**METROPOLITAN GOVERNMENT OF NASHVILLE AND DAVIDSON COUNTY**

**STAFF RECOMMENDATION**  
**1203 B Lillian Street**  
**May 15, 2019**

**Application:** New Construction--Infill  
**District:** Lockeland Springs-East End Neighborhood Conservation Zoning Overlay  
**Council District:** 06  
**Base Zoning:** R6  
**Map and Parcel Number:** 08313012200  
**Applicant:** Ashley Quinn, Cygnus Construction, LLC  
**Project Lead:** Sean Alexander, sean.alexander@nashville.gov

**Description of Project:** A proposal to construct a new house on a lot with two street frontages, on which there is currently a house facing Fatherland Street. The new house will face Lillian Street and will be one and one-half-stories tall.

<b>Site Plan</b>		<b>H1</b>
Date	5/2/2019	
Drawn by	MP	Scale 1" = 20'-0"

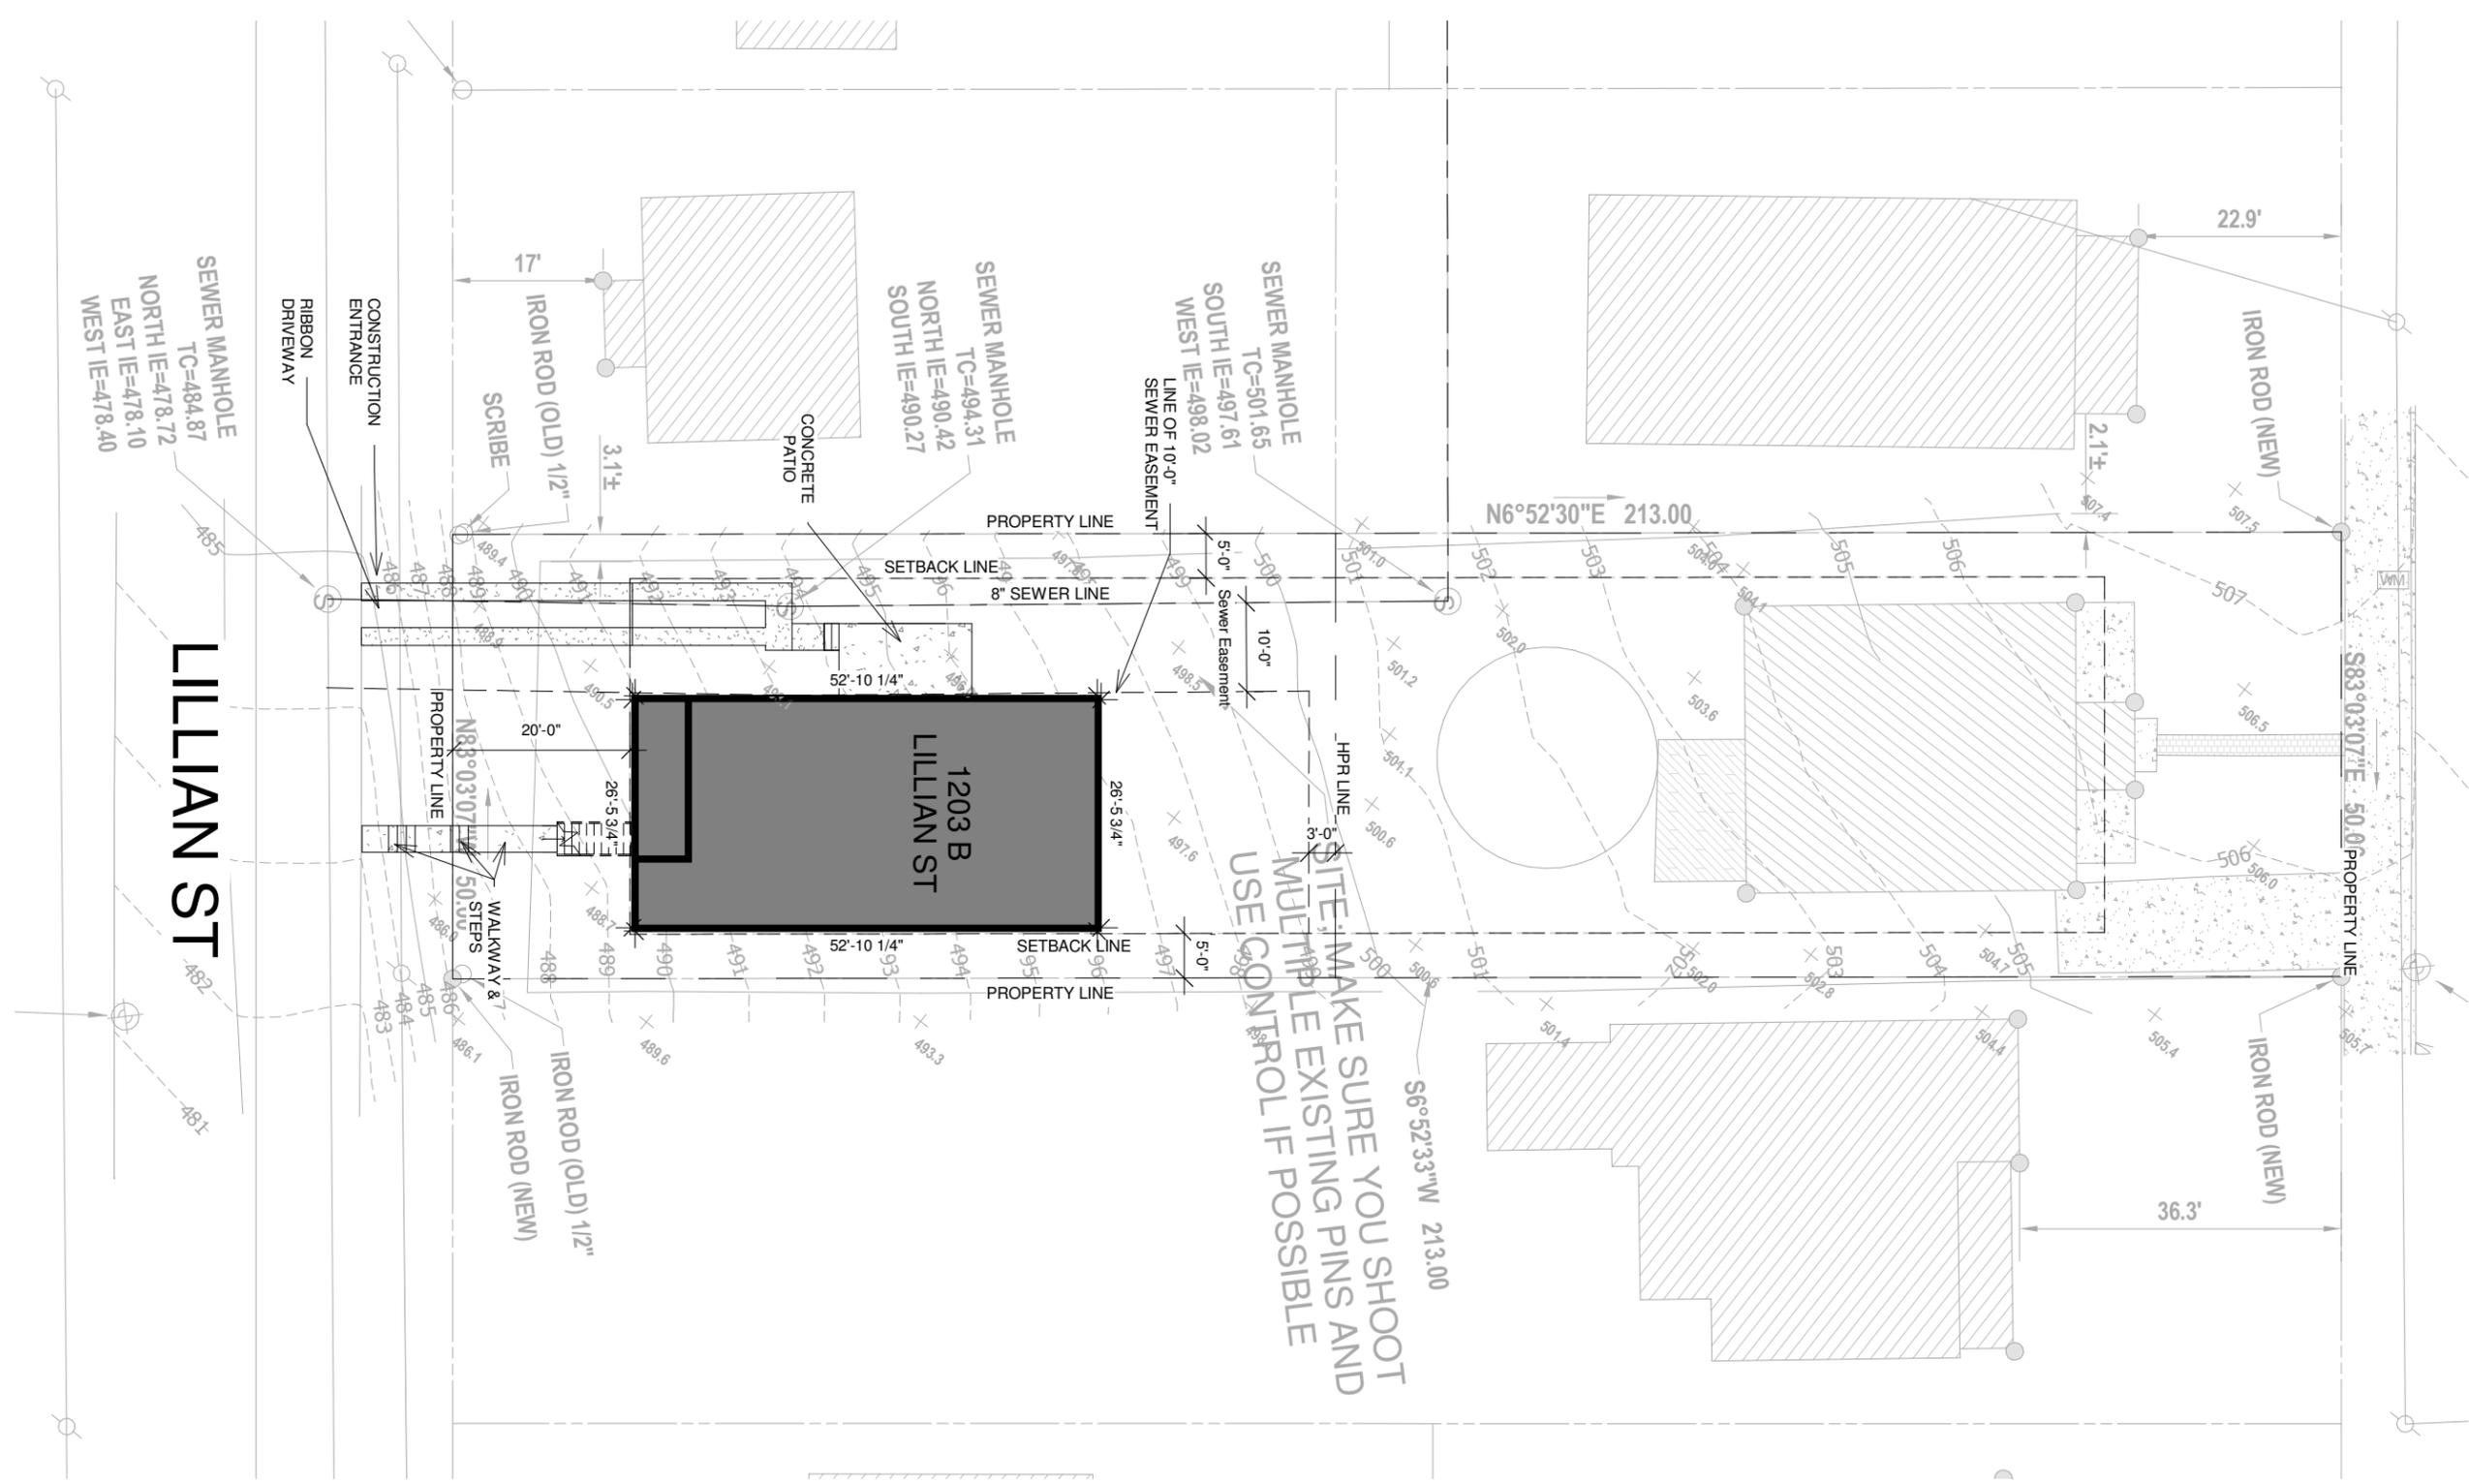
**Appurtenances & Utilities:** The site plan shows a new walkway added from the porch to the front of the property, and driveway strips will be constructed along the left side of the

lot from the street to the approximate midpoint of the building. The location of the HVAC and other utilities were not noted.

With the condition that the HVAC is located on the rear façade, or on a side façade beyond the midpoint of the house, Staff finds the appurtenances will be compatible with surrounding historic properties and will meet section II.B.9 of the design guidelines.

Front Elevation

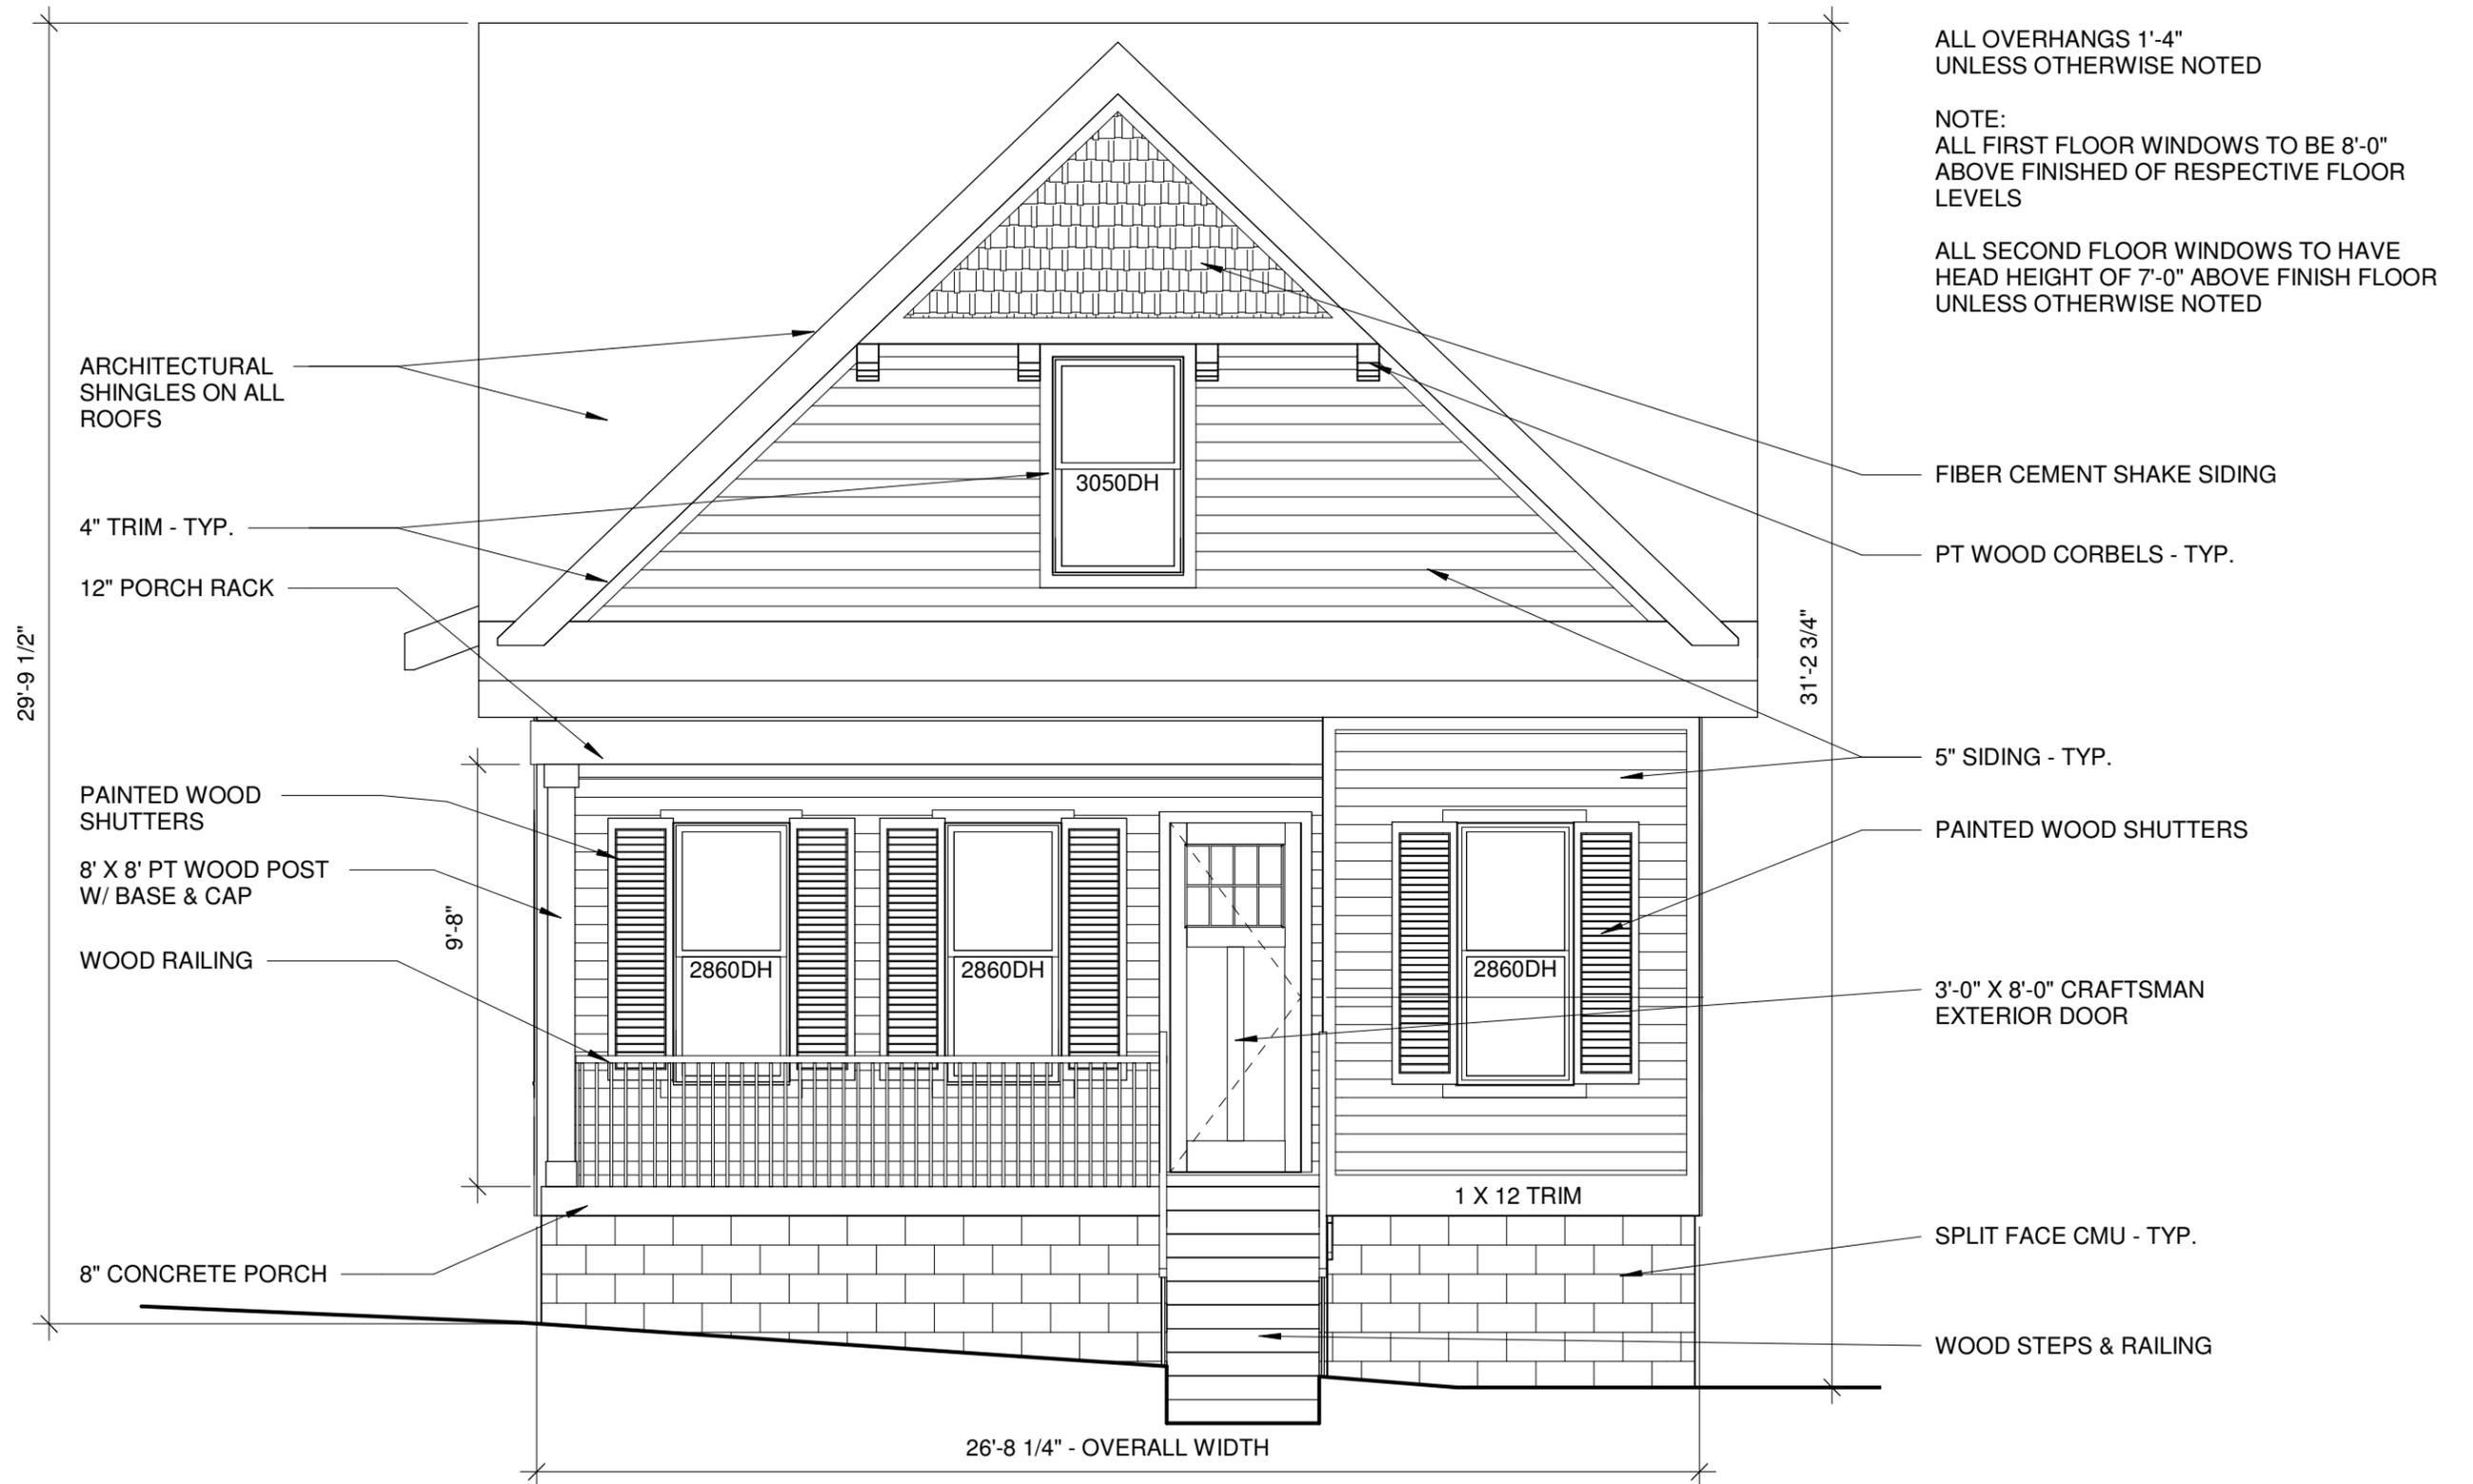
**Height & Scale:** The new building will be a one and one-half-story house, which is compatible with the houses on the block and the surrounding area. The house will be twenty-five feet, six inches (25'-6") tall from the floor level to the peak of the roof. The height of the foundation will vary between two feet (2') and five feet (5'), depending on grade. With an approximately ten inch (10") wide water-table band below the floor level the maximum height of the house will be approximately thirty-one feet (31') from grade. The primary eave height on the building will be ten feet (10') tall, from floor level. This matches the height and massing of two recently constructed houses on this block face: 1113 and 1115 Lillian Street.

The front facade of the building will be approximately twenty-seven feet (27') wide, and the depth of the building will be fifty-one feet (51'). This width is compatible with nearby houses including recent infill, which range from twenty-eight to thirty-eight feet (28'-38') wide and up to sixty-one feet (61') deep.

**Roof form:** The primary roof of the building will be a cross-gable, with a front-to-back primary axis. The pitch of the front-facing gable will be 12/12. The side-oriented gables will be 11/12 pitch on one slope and 14/12 on the other-

**Proportion and Rhythm of Openings:** The window openings on the new building will be vertically oriented, arranged in single windows and pairs of single-light sashes of double-hung and fixed sashes. The sizes and spaces between openings on the primary facades will be consistent with the openings on nearby historic houses. The plans show shutters on the first-story windows of the front façade and while these shutters may not be operable, they are appropriately scaled for the window sizes.

Staff finds that the window proportions and rhythms are generally compatible with the surrounding context and that the project will meet section II.B.7 of the design guidelines.
